Planning Authority Case Officer: [REDACTED]
Planning Application Ref: LA05/2021/1372/RM
Date consultation received: 10/01/2022
Date of Reply: 17/02/2022

Location: 30m North of 75 Dromore Road, Hillsborough.**Proposal:** Dwelling.

Planning Authority Case Officer: Ms Catherine Gray
Planning Application Ref: LA05/2021/0276/RM
Date consultation received: 18/05/2021
Date of Reply: 25/05/2021

Planning Authority Case Officer: Ms Catherine Gray
Planning Application Ref: LA05/2021/0276/RM
Date consultation received: 01/04/2021
Date of Reply: 22/04/2021

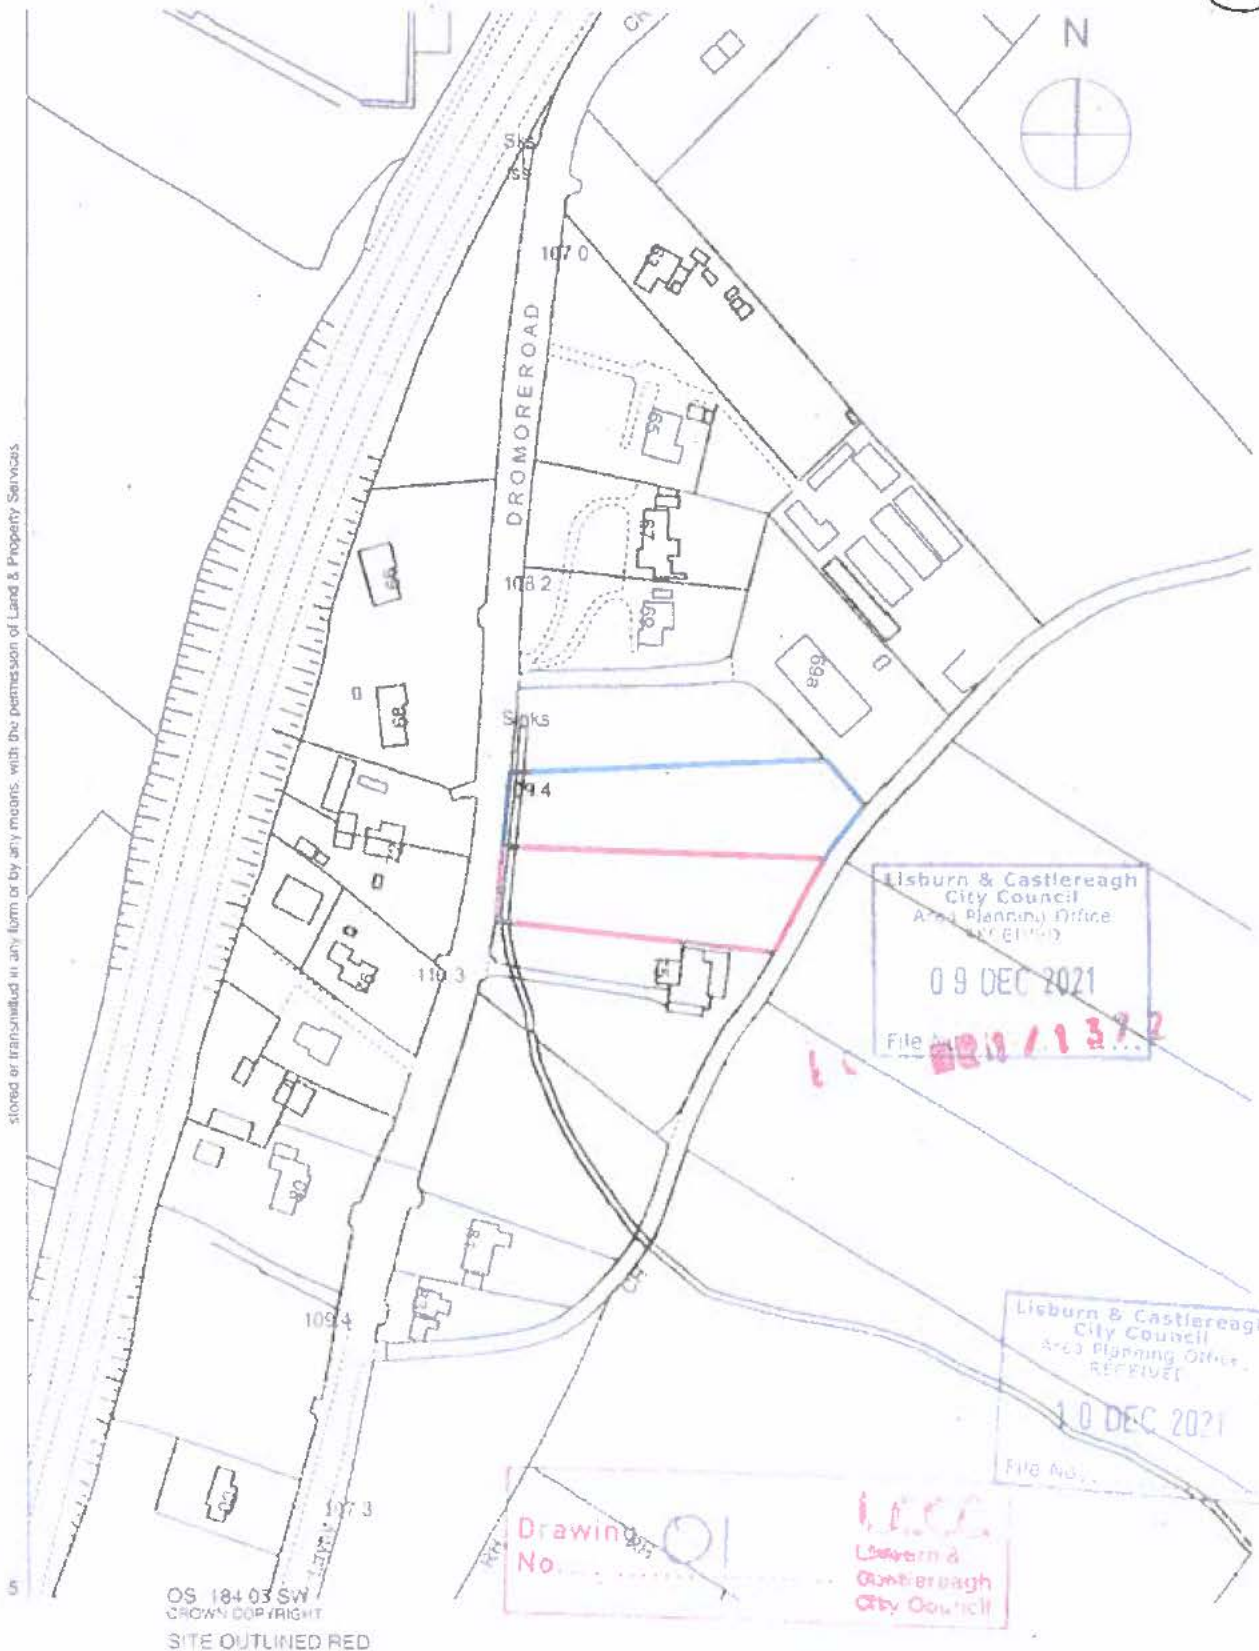
1. The vehicular access, including any visibility splays and any forward sight distance, shall be provided in accordance with Drawing No. 02, bearing the date stamp 10 December 2021, prior to the commencement of any other works or other development hereby permitted. The area within the visibility splays and any forward sight line shall be cleared to provide a level surface no higher than 250 mm above the level of the adjoining carriageway and such splays shall be retained and kept clear thereafter.
REASON: To ensure there is a satisfactory means of access in the interest of road safety and the convenience of road users.

3. No dwelling shall be occupied until hard surfaced areas have been constructed in accordance with approved drawing no. 02, bearing date stamp 10 December 2021 to provide adequate facilities for parking and circulating within the site. No part of these hard surfaced areas shall be used for any purpose at any time other than for the parking and movement of vehicles.

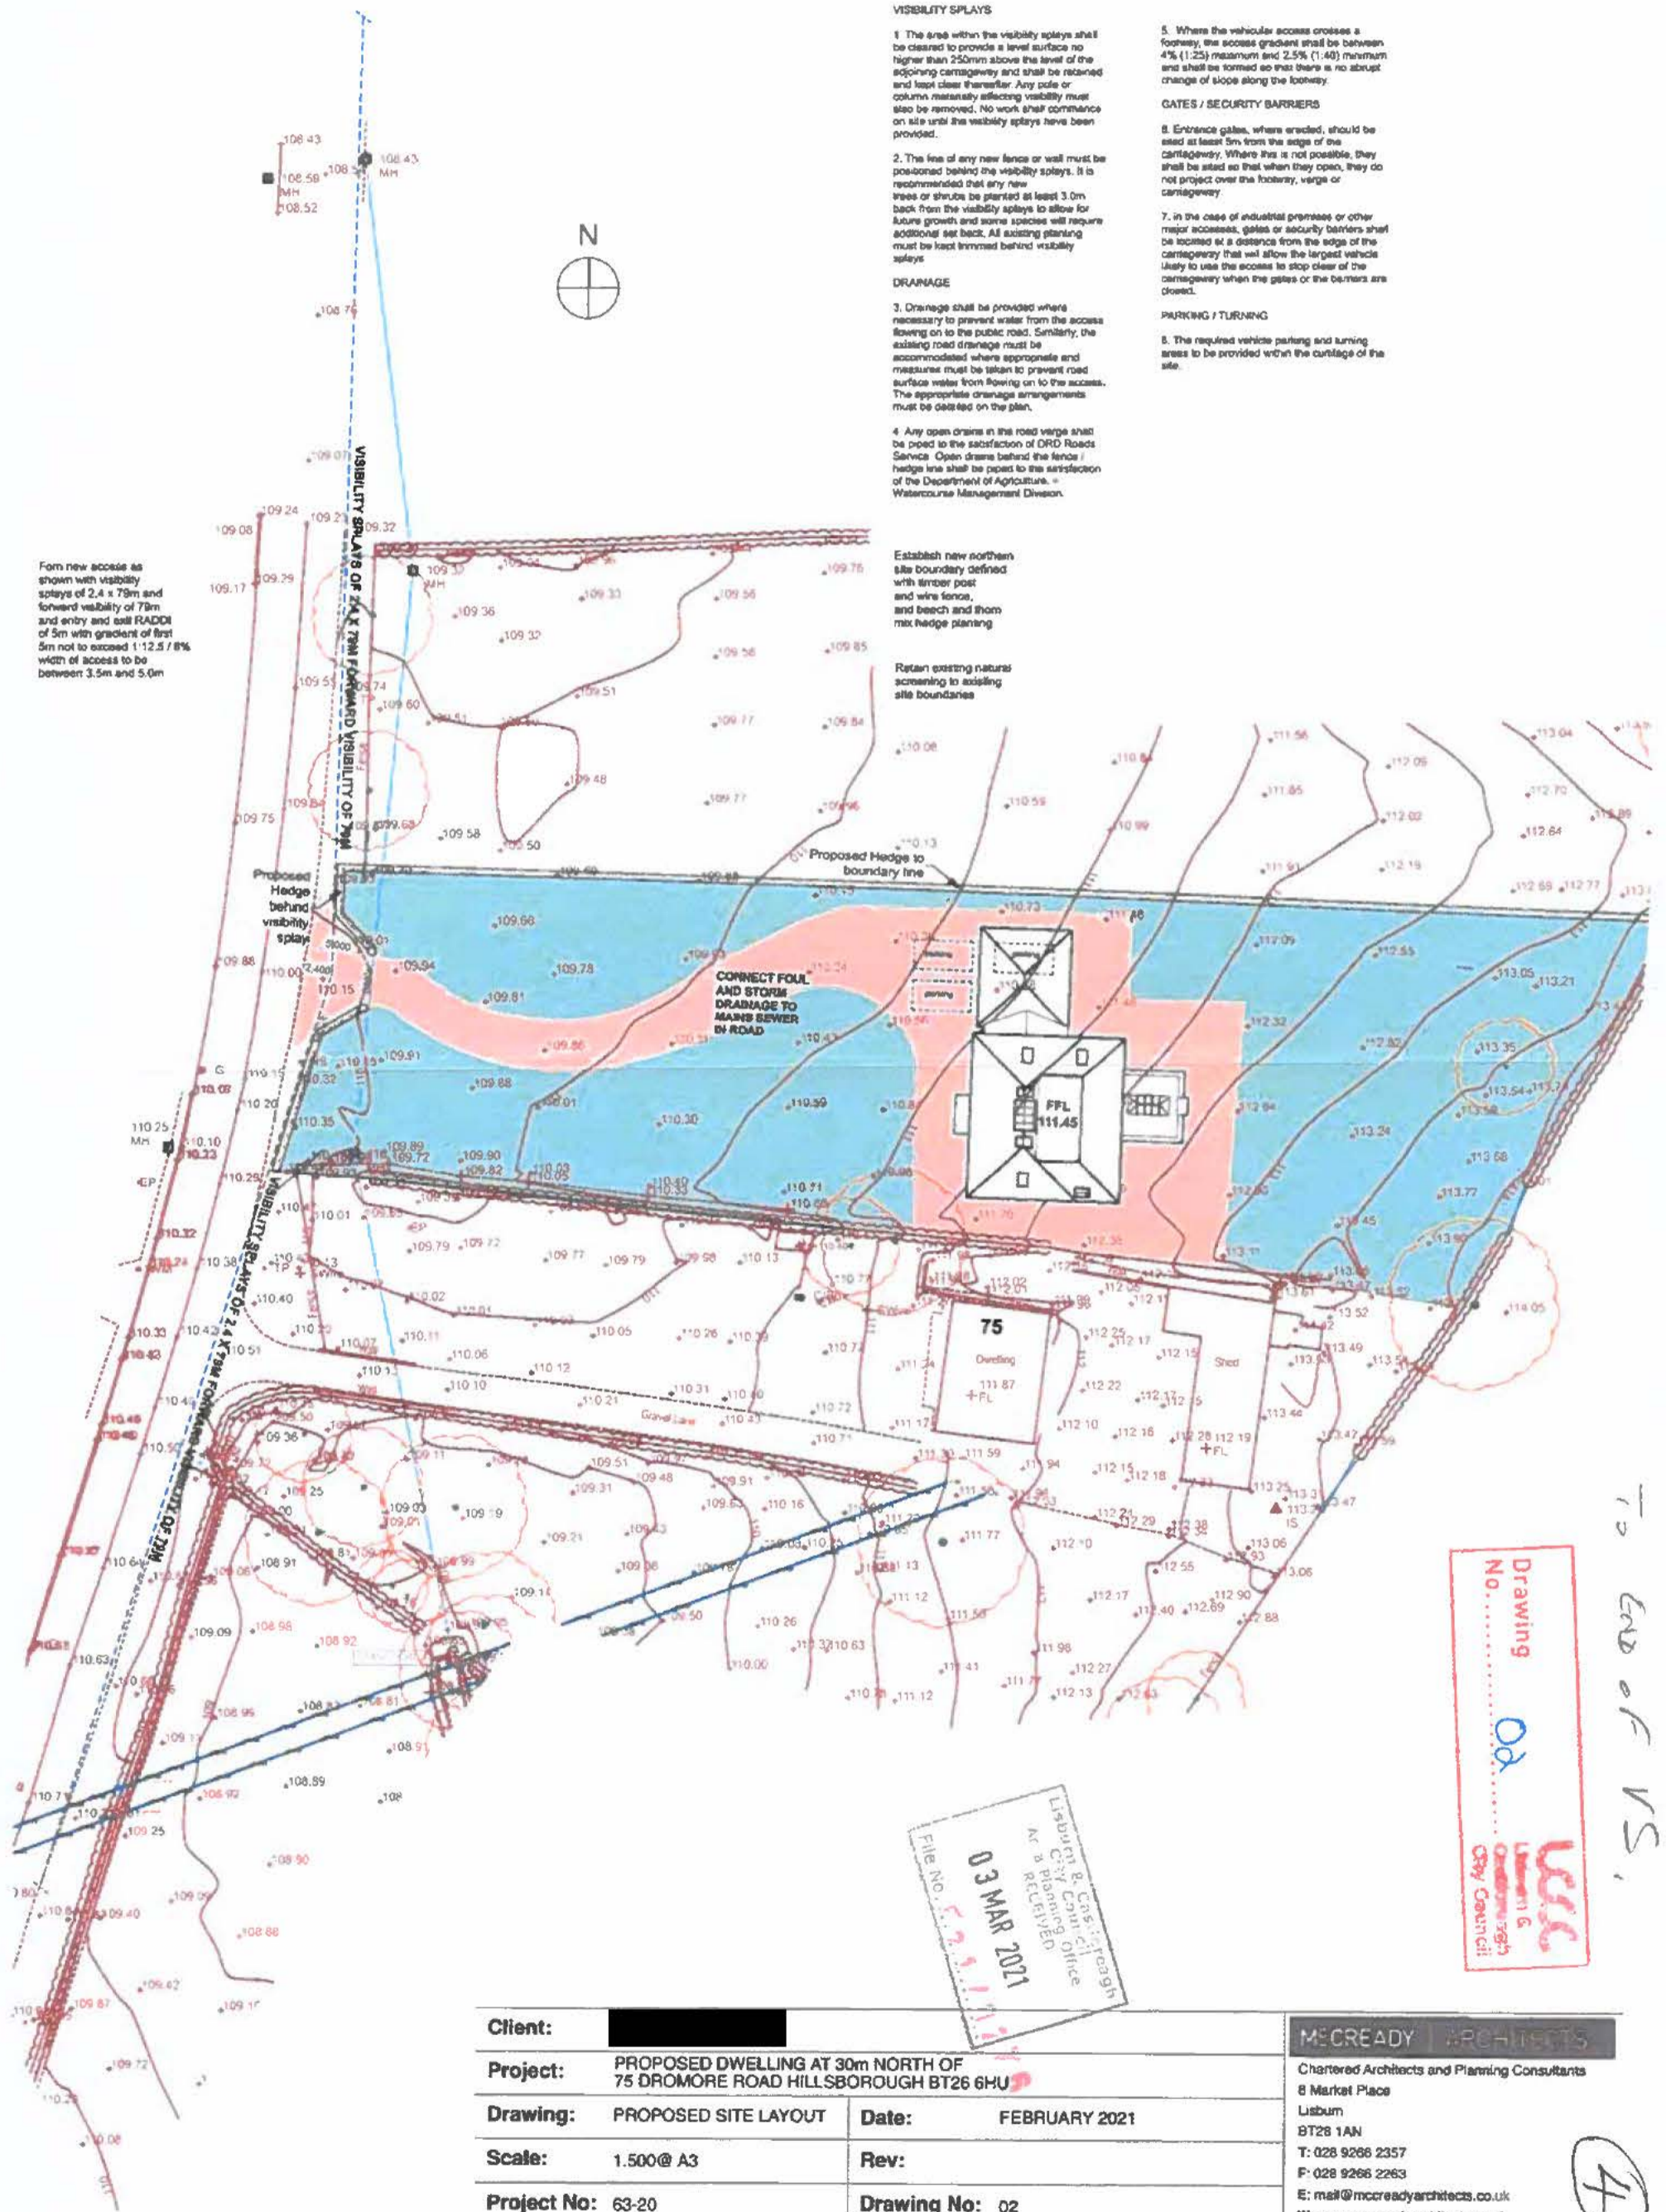
1. Provide a 'Clear Fully Dimensioned Engineering Drawing' showing the access and driveway, i.e. visibility splays, forward sight lines and access widths and parking space dimensions to the requirements of the Department's Development Control Advise Note 15.
2. The carriageway edge must be shown along the extent of the visibility splays in both directions.
3. The visibility splays must be drawn to the tangents of the road curves.

REF	SUMMARY	ACTION
	<p>LA05/17/1038/0 - US = 2.4 x 79 ~</p> <p>- NEED FULL EXTENT OF CARRIAGEWAY EDGE TO BE SHOWN ALONG FULL LENGTH OF SPAYS.</p> <p>- DRAWN TO TANGENTS.</p>

+ SHOW EXTENT OF ROAD BOUNDARY
 + UNK '10' HANGOUTS
 TO END OF VS

DIAGRAM 1: ACCESS FOR SINGLE DWELLING Option A

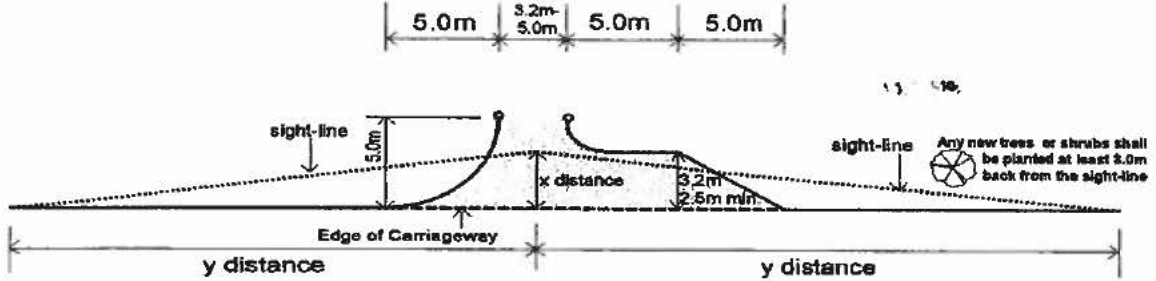
1. Layout to be generally in accordance with diagram 1 overleaf
2. Visibility Splays **X = 2.4** metres **Y = 79** metres
3. Width of Access (if different from diagram) **3.2 - 5.0 m** Forward Sight Distance **79m**
5. Minimum radii (if different from diagram). Entry **5** metres. Exit **5** metres.
6. Gradient of the access not to exceed 1:12.5 (8%) over the first 5 metres outside the road boundary. i.e., from the back of the verge/back of footway/fence-line/edge of carriageway.
7. Access position – Positioned to ensure visibility and forward sight distance are achieved
Other Requirements – Access positioned to ensure visibility requirements are achieved.
8. SIGNED **D Bramall** DATE **07 Nov 2017**
